# UNITED STATES PATENT AND TRADEMARK OFFICE

APPLICATION NO.	FILING DATE	FIRST NAMED INVENTOR	ATTORNEY DOCKET NO.	CONFIRMATION NO.
10/619,381	07/14/2003	Rajendra D. Pendse	CPAC 1015-1	5430
22470	7590	12/14/2004	EXAMINER	
HAYNES BEFFEL & WOLFELD LLP			ORTIZ, EDGARDO	
P O BOX 366			ART UNIT	
HALF MOON BAY, CA 94019			PAPER NUMBER

<b>Office Action Summary</b>	<b>Application No.</b> 10/619,381	<b>Applicant(s)</b> PENDSE, RAJENDRA D.	
	<b>Examiner</b> Edgardo Ortiz	<b>Art Unit</b> 2815

FIG. 3A

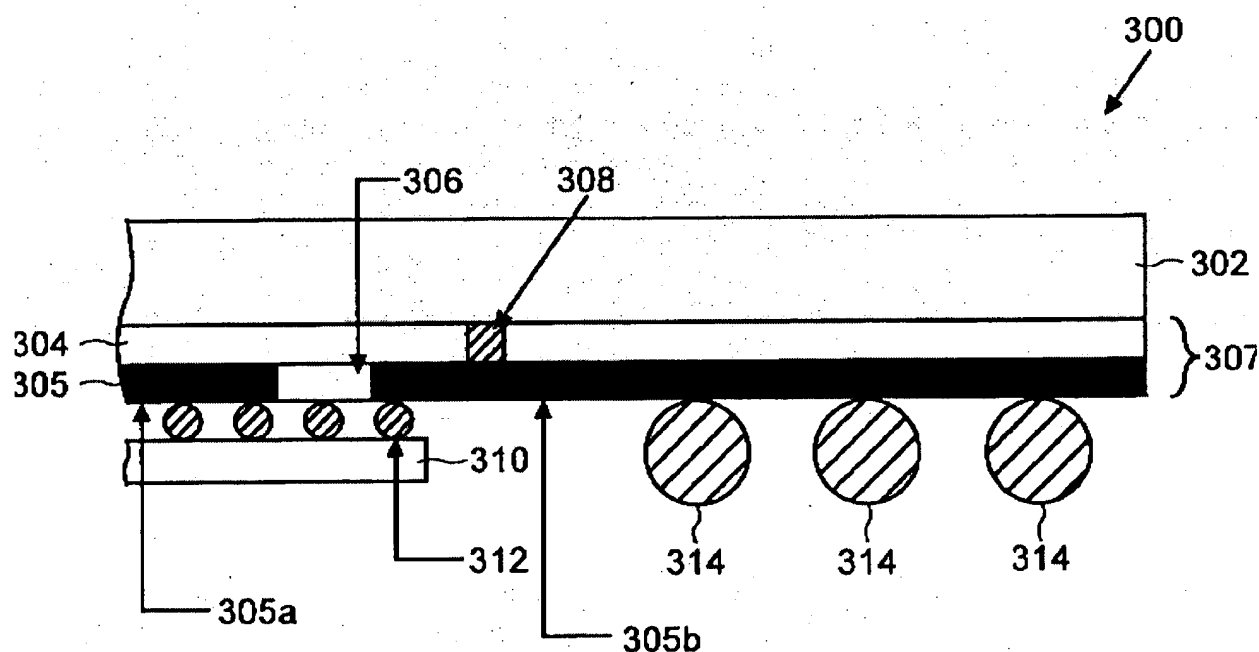
Claims 1, 2, 7, 10, 14, 20-23 are rejected under 35 U.S.C. 102(e) as being anticipated by Shenoy (U.S. Patent No. 6,310,386). With regard to Claim 1, Shenoy discloses a chip-scale integrated

circuit chip package (column 5, lines 55-57) comprising a die (310) mounted by flip-chip interconnection (column 8, line 49) to a package substrate (307), the package substrate being a laminate (column 8, lines 50-53) comprising a dielectric layer (304) having a single conductive trace layer (305) on a first surface thereof (figure 3A) and an active ground plane (302) overlying a second surface thereof (figure 3A), wherein the ground plane is electrically connected to ground sites at the first surface of the dielectric layer through openings (308) in the dielectric layer (column 9, lines 2-6 and figure 3A), and wherein second level interconnects are on the first surface of the dielectric layer (column 8, line 67 and column 9, lines 1-2), and the die is mounted on the first surface of the dielectric layer (figure 3A).

With regard to Claim 2, Shenoy discloses openings (308) in the dielectric layer (304) that are filled with an electrically conductive material (column 9, lines 2-6).

With regard to Claim 7, Shenoy discloses a ground plane (302) that comprises an electrically conductive film overlying the second surface of the dielectric layer (column 8, line 50; column 9, lines 5-6 and figure 3A).

With regard to Claim 10, Shenoy discloses a ground plane (302) that is disposed directly upon the surface of the dielectric layer (304) on the dielectric side (column 8, lines 50-53 and figure 3A).

With regard to Claim 20, Shenoy discloses a die (310) that is provided with interconnection bumps (312) affixed to an arrangement of connection sites in a first surface of the die (column 8, lines 65-67) and a conductive trace layer (305) that is provided with a complementary arrangement of interconnect sites (column 8, lines 51-62), and a flip-chip interconnection (column 8, lines 43-44 and 49-50) in a solid state interconnection.

With regard to Claim 21, Shenoy discloses a die (310) that is attached (column 8, lines 65-67) at about a center of the first side (figure 3A) of the substrate (307), and solder balls (314) for

second level interconnections that are located nearer the periphery of the first side of the substrate.

With regard to Claim 22, Shenoy discloses electrical traces that are formed within an interconnect layer (305) in the first surface of the package substrate (307), and the traces fan outward from the interconnect pads to the solder ball (314) attachment sites, (column 8, lines 52-56 and figure 3A).

With regard to Claim 23, Shenoy discloses some of the traces constructed as coplanar waveguides (column 8, lines 44-48), each comprising ground lines alongside a signal line (column 8, lines 60-62) on a coplanar dielectric material (figure 3A).
